PROPOSED TECHNICAL SPECIFICATION CHANGE

SEQUOYAH NUCLEAR PLANT UNIT 2

(TVA-SQN-TS-88-18)

DESCRIPTION AND JUSTIFICATION FOR
EXTENDING SURVEILLANCE REQUIREMENT
FOR ICE CONDENSER ICE WEIGHING

FIGURE 1

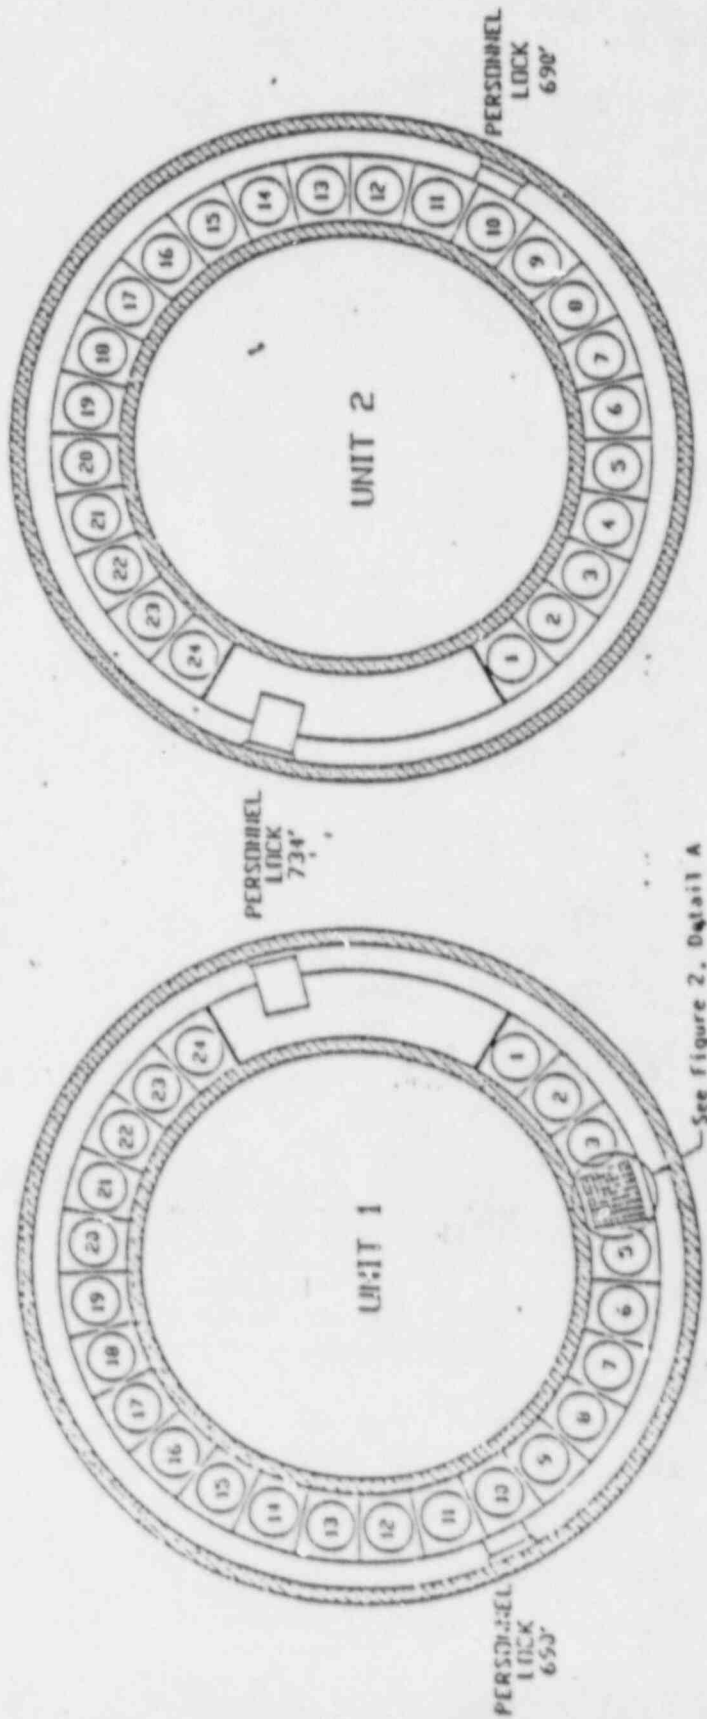
In order to ensure a sufficient quantity of ice is available, the technical specification SR 4.6.5.1 requires that a sample of at least 144 ice baskets be weighed on a 12-month basis. This sample includes one basket from six rows (radial rows 1, 2, 4, 6, 8, and 9) of each of the 24 bays (refer to the attached figures 1 and 2 of this enclosure for a representation of ice condenser bays, groups, and rows). If any basket is found to contain less than 1,200 pounds of ice, an additional 20 baskets must be weighed. The rows are then subdivided into three groups (group 1 - bays 1 through 8, group 2 - bays 9 through 16, group 3 - bays 17 through 24). The minimum average weight of the group-row combinations and bays must not be less than 1,200 pounds per basket at a 95-degree level of confidence. In addition, these basket weights shall be used to determine that the overall ice weight is not less than 2,333,100 pounds.
